SUBJECT: **DEMONSTRATION / DELIVERY HOLD - Safety Recall 13S04 – Supplement #5**
Certain 2013 Model Year Explorer, Taurus, MKS, Flex, MKT, Fusion, MKZ, and Police
Interceptor Utility and Sedan Vehicles
Fuel Delivery Module Replacement

REF : **DEMONSTRATION / DELIVERY HOLD - Safety Recall 13S04 – Supplement #4**
Dated August 19, 2013

New! REASON FOR THIS SUPPLEMENT

FIGURE 1

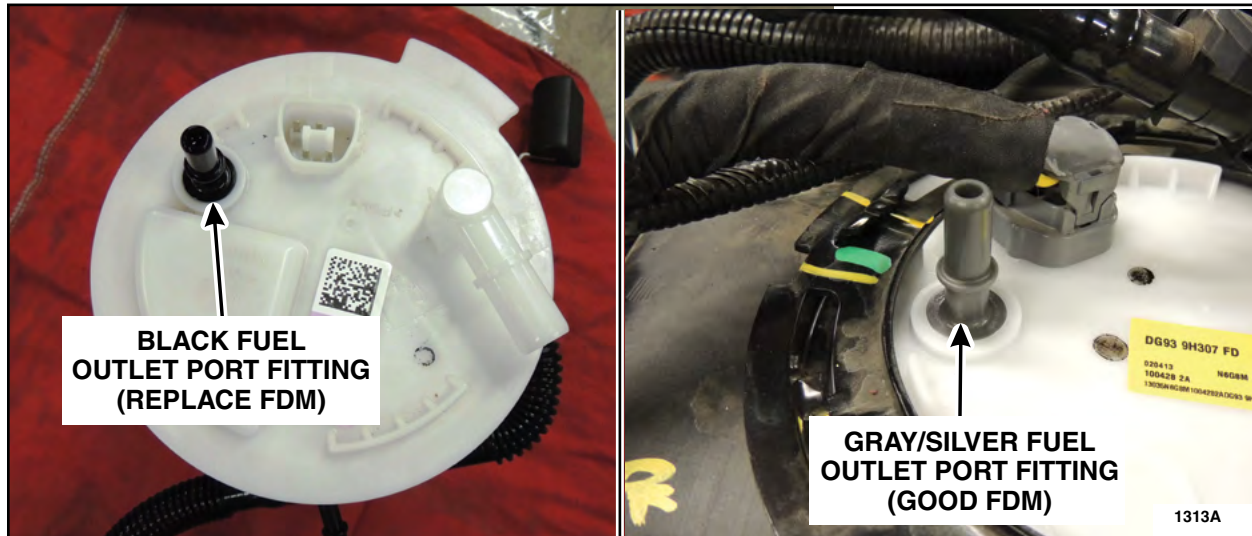
3. Remove the fuel tank. For additional information, refer to WSM Section 310-01.
4. Inspect the color of the fuel outlet port fitting on top of the FDM. See Figure 1.
 - If the color of the fuel outlet port fitting is black, replace the FDM. For additional information, refer to WSM Section 310-01.
 - If the color of the fuel outlet port fitting is gray/silver, no further action is necessary. Reinstall the fuel tank. For additional information, refer to WSM Section 310-01.
